Summary of Public Review Comments and Responses:
Draft Inventory of U.S. Greenhouse Gas Emissions and Sinks: 1990-2020

June 2022
U.S. Environmental Protection Agency
Office of Atmospheric Programs
Washington, D.C.

Responses to Comments Received during the Public Review Period on
the *Inventory of U.S. Greenhouse Gas Emissions and Sinks: 1990-2020*

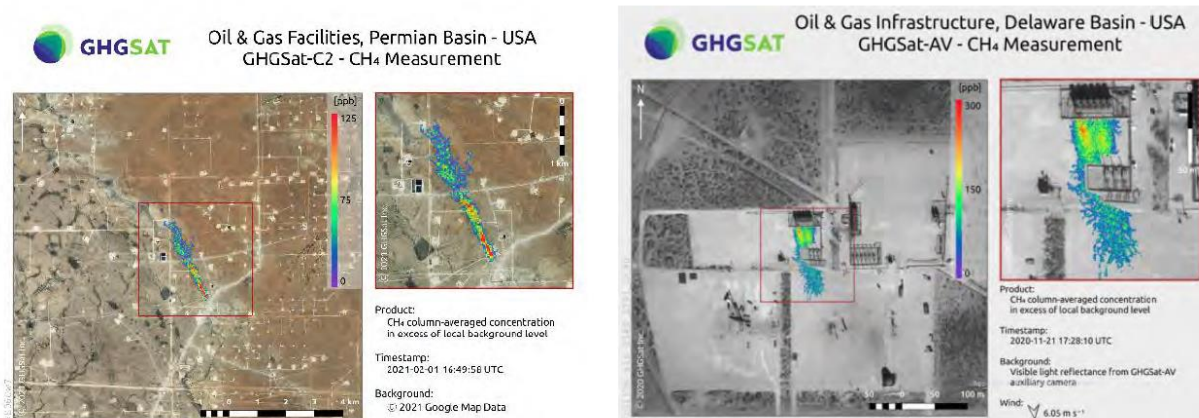
The image below on the left was taken by a GHGSat satellite and shows a methane super-emitter in the Permian Basin in western Texas, while the image on the right shows an observation of a methane leak at a compressor station also in the Permian taken by the airborne instrument that complements the satellite constellation – an existing and operational system-of-systems for greenhouse gas measurement.

The Draft Inventory of U.S. Greenhouse Gas Emissions and Sinks 1990-2020 states that “EPA continues to examine the uses of facility-level...data to improve the national estimates” [Energy, Page 3-6], that “additional efforts will be made for future Inventory reports to improve the mapping of fuel types and examine ways to reconcile and coordinate any differences between facility-level data and national statistics” [Energy, Page 3-22], and that “EPA also continues to seek new data that could be used to assess or update the estimates in the Inventory.” [Energy, Page 3-86] A tiered system-of-systems approach that leverages the remote sensing capabilities of satellites and aircraft-based instruments could dramatically improve the Inventory and help reconcile differences between facility-level data and

Response: In the text of the GHG Inventory (pp. 3-96 to 3-97 of Chapter 3, Section 3.7 Natural Gas Systems), we note that: “In general, there are two major types of studies related to oil and gas greenhouse gas data: studies that focus on measurement or quantification of emissions from specific activities, processes and equipment, and studies that use tools such as inverse modeling to estimate the level of overall emissions needed to account for measured atmospheric concentrations of greenhouse gases at various scales. The first type of study can lead to direct improvements to or verification of Inventory estimates. In the past few years, EPA has reviewed and in many cases, incorporated data from these data sources. The second type of study can provide general indications of potential over- and under-estimates. In addition, in recent years information from top-down studies has been directly incorporated to quantify emissions from well blowouts.”

Figure 1. Trends in U.S. anthropogenic methane emissions 1990-2020 showing increases methane emissions from animal agriculture over time. Data from draft Inventory.

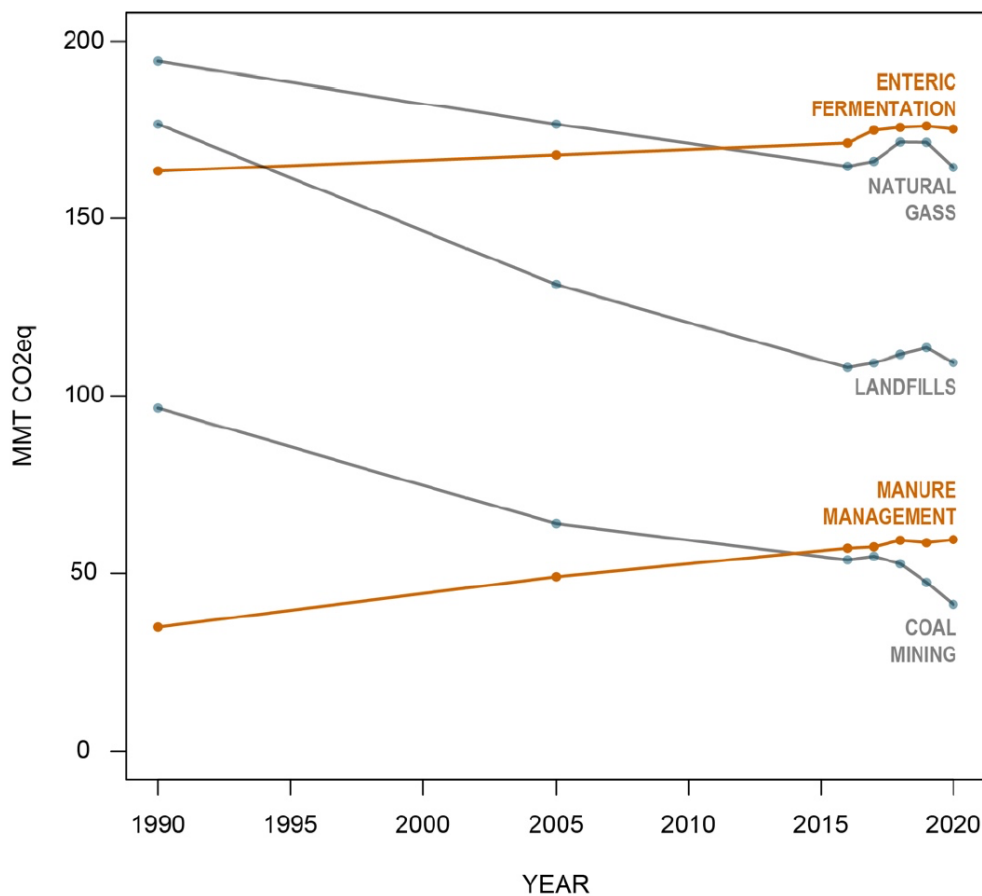
Agriculture is the largest source of anthropogenic methane and nitrous oxide emissions in the U.S. Agricultural soil management emissions rose from 316.0 MMT CO₂eq to 345.3 MMT CO₂eq between 1990 and 2019, although these values fell during 2020.³ Despite some sectors' progress in curbing or slowing the growth of methane emissions, enteric fermentation emissions have risen from 163.5 to 175.2 MMT CO₂eq between 1990 and 2020, and manure emissions have nearly doubled from 34.8 to 59.6 MMT CO₂eq during this same period (See Figure 1)¹. Thus, these non-CO₂ greenhouse gas emissions are of growing importance and will continue to pose a threat to meeting climate targets in the absence of aggressive mitigation measures. An accurate and precise estimate of these emission sources is necessary to shape such efforts.

Response: As described in the final Inventory, EPA in collaboration with USDA survey and census programs has undertaken a number of improvements within the 1990-2020 Inventory, including updates to the Cattle Enteric Fermentation Model (CEFM), and continues to identify and plan improvements for future Inventories, including a number of updates to the models and data used to calculate emissions within the agriculture and LULUCF sectors. As noted in the Planned Improvement sections of the Agriculture and LULUCF chapter, some improvements will take longer to implement due to the complexity of the analysis.

Figure 2. U.S. 2020 agricultural greenhouse gas emissions with 95% confidence intervals showing large uncertainties in model estimates. Data from draft Inventory.

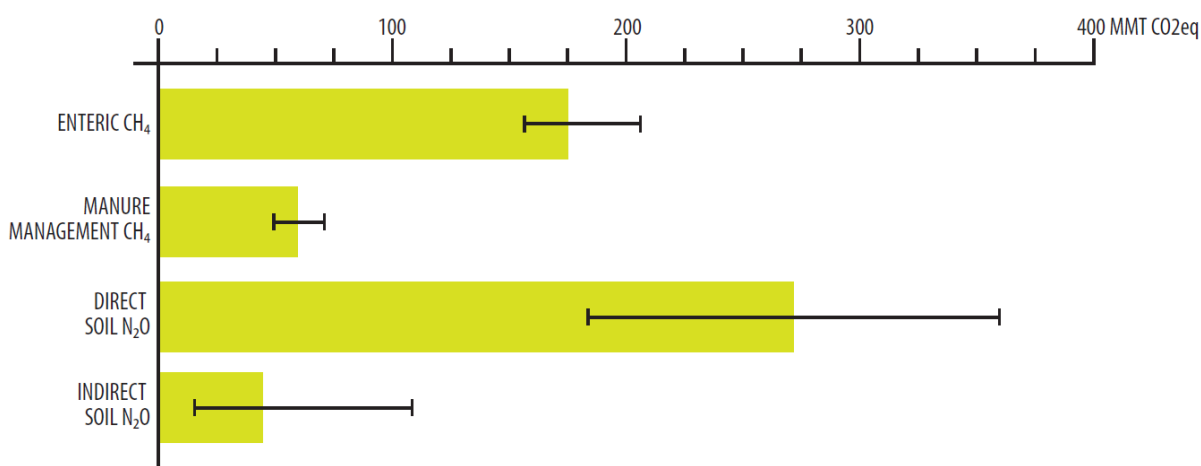
These uncertainties are among the largest in the Inventory. For example, the 95% confidence interval² surrounding estimates of methane emissions from enteric fermentation and manure management range from nearly 20% below to 20% above the given values,³ reflecting a critical need for model improvement (See Figure 2). Even more concerning, estimates of direct soil nitrous oxide emissions are only constrained to $\pm 33\%$ of the given values, and the 95% confidence interval for indirect soil emissions ranges up to 145% above the given values.⁴ These broad ranges of uncertainty have not improved substantially across successive annual inventories, reflecting slow progress on improving the precision of these critical estimates. EPA should accelerate efforts to improve underlying models, including the steps it outlines in the planned improvements sections of the Inventory.

Figure 1. Trends in U.S. anthropogenic methane emissions 1990-2020 showing increases methane emissions from animal agriculture over time. Data from draft Inventory.

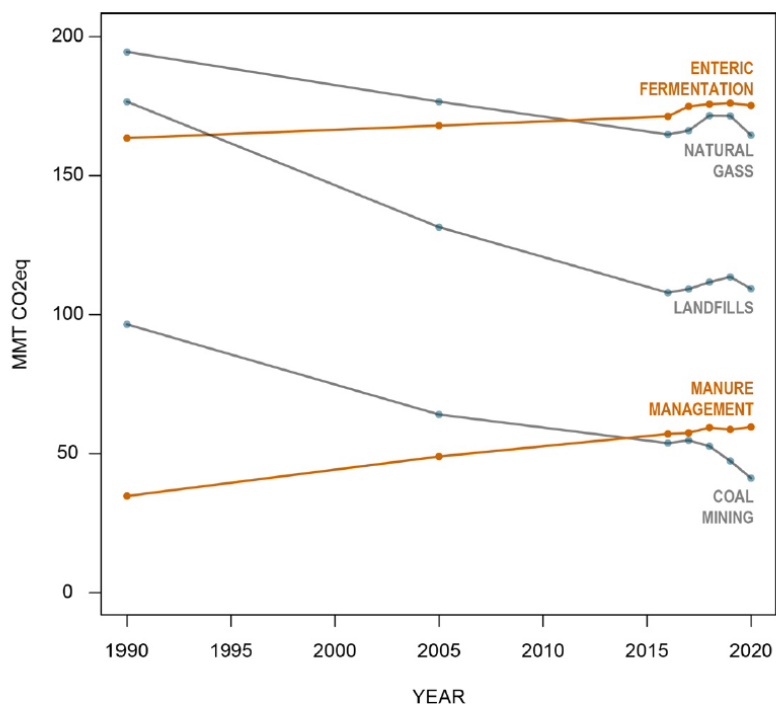
Agriculture is the largest source of anthropogenic methane and nitrous oxide emissions in the U.S. Agricultural soil management emissions rose from 316.0 MMT CO₂eq to 345.3 MMT CO₂eq between 1990 and 2019, although these values fell during 2020.³⁰ Despite some sectors' progress in curbing or slowing the growth of methane emissions, enteric fermentation emissions have risen from 163.5 to 175.2 MMT CO₂eq between 1990 and 2020, and manure emissions have nearly doubled from 34.8 to 59.6 MMT CO₂eq during this same period (*See Figure 1*).³¹ Thus, these non-

Response: See response to Comment #2, above.

Figure 2. U.S. 2020 agricultural greenhouse gas emissions with 95% confidence intervals showing large uncertainties in model estimates. Data from draft Inventory.

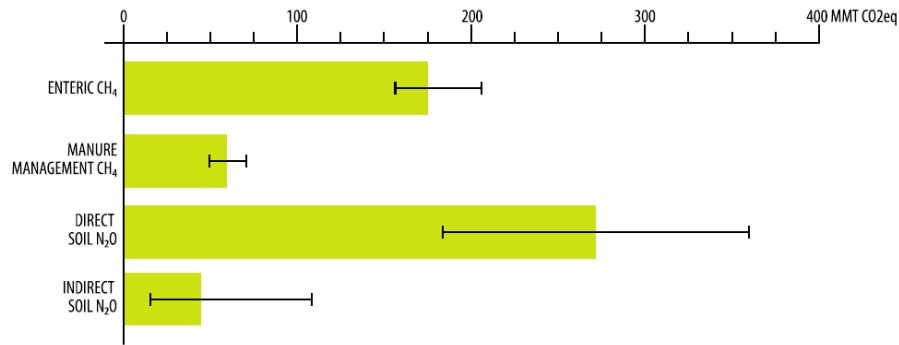
As noted in the Inventory, there are a number of challenges associated with estimating agricultural emissions, leading to wide uncertainty ranges for these major emission sources. These uncertainties are among the largest in the Inventory. For example, the 95% confidence interval³² surrounding estimates of methane emissions from enteric fermentation and manure management range from nearly 20% below to 20% above the given values,³³ reflecting a critical need for model improvement (See Figure 2). Even more concerning, estimates of direct soil nitrous oxide emissions are only constrained to $\pm 33\%$ of the given values, and the 95% confidence interval for indirect soil emissions ranges up to 145% above the given values.³⁴ These broad ranges of uncertainty have not improved substantially across successive annual inventories, reflecting slow progress on improving the precision of these critical estimates. EPA should accelerate efforts to improve underlying models, including the steps it outlines in the planned improvements sections of the Inventory.

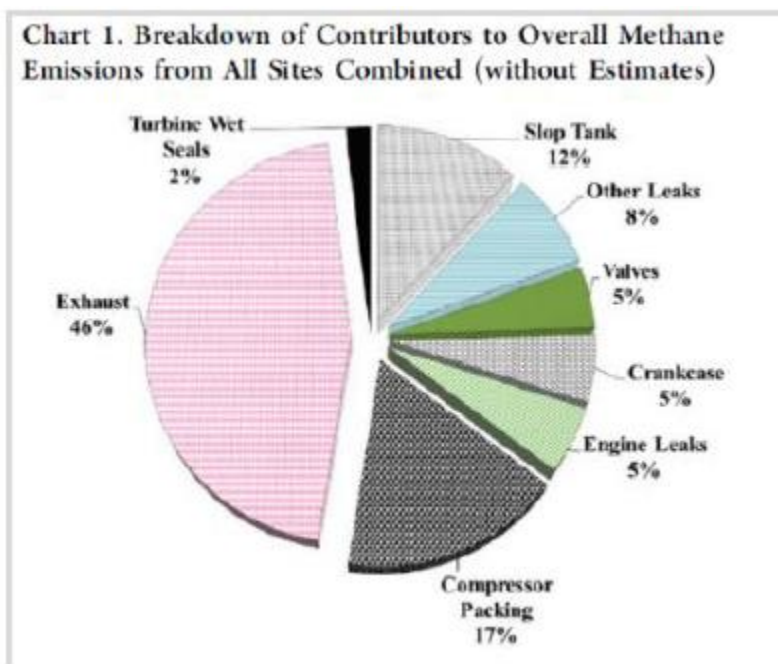
Per chart 1⁶² below, methane slip from exhaust represents 46% of compressor site emissions. This data is based on research findings conducted to measure methane emissions from natural gas compressor stations and storage facilities.² As a result, nearly half of a compressor station and or storage facility’s emissions are significantly underestimated utilizing current emission factor methodologies.

Response: The EPA continues to work through its stakeholder process to review new data from the EPA’s Greenhouse Gas Reporting Program (GHGRP) and research studies to assess how emissions estimates can be improved and will assess new information on gas engines (such as any data on the national population of lean versus rich-burn engines) as it becomes available. The GHGRP is currently proposing revisions to improve the quality of the data collected and to establish or amend confidentiality determinations. For more information, please see <https://www.epa.gov/ghgreporting/rulemaking-notices-ghg-reporting>.

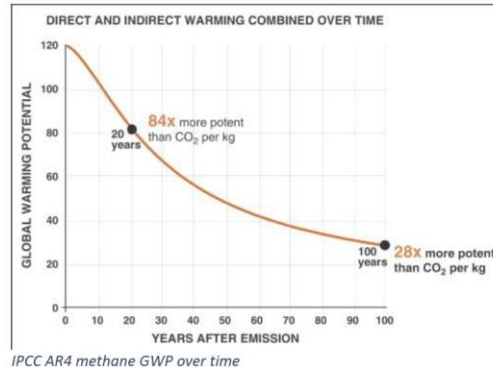
Methane's global warming potential starts at 120 times carbon dioxide at the moment of emission and then oxides over time, losing its potency. Other factors are captured in a recent published report:

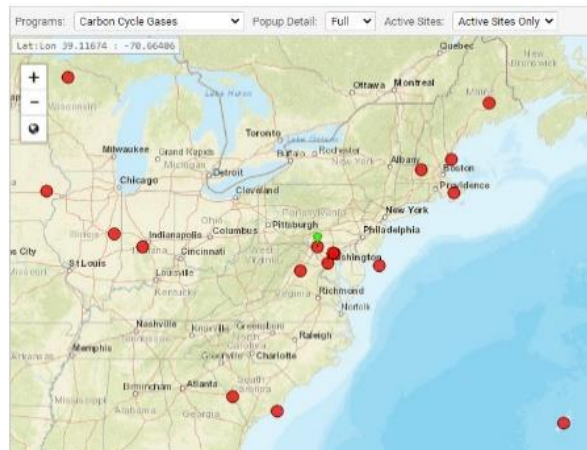
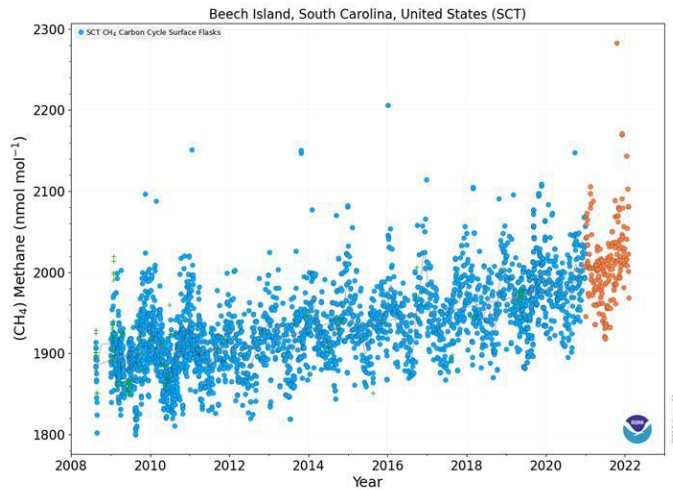
On the EPA website, it states (my highlighting): “The Global Warming Potential (GWP) was developed to allow comparisons of the global **warming impacts of different gases**. Specifically, it is a measure of **how much energy the emissions of 1 ton of a gas will absorb over a given period of time**, relative to the emissions of 1 ton of carbon dioxide (CO₂).” (Link: <https://www.epa.gov/ghgemissions/understanding-global-warming-potentials>)

As we can see from NOAA’s methane atmospheric concentration monitors (link: <https://gml.noaa.gov/dv/iadv/>), the concentration of methane varies from region to region and is influenced by the various sources of the methane emissions in each region. Warming Potential measures “the heat absorbed by any greenhouse gas in the atmosphere, as a multiple of the heat that would be absorbed by the same mass of carbon dioxide (CO₂).” (Link: https://en.wikipedia.org/wiki/Global_warming_potential) This is highly dependent on the regional methane emission sources. IPCC actually presents different data sets for direct fossil fuel emissions, natural bio methane emissions and emissions that are a combination of both sources. The NOAA’s methane concentration monitoring can indicate how close to being cyclic the methane concentration is, which can be tied directly to human behavior causes (fossil fuel emissions) through heating and energy consumption that is seasonal. Unfortunately, most of NOAA methane atmospheric monitoring locations in the Northeast US do not collect methane emissions and none use real time monitoring towers (in Situ Observatory). For example, Beach Island SC uses manual flask captured measures.
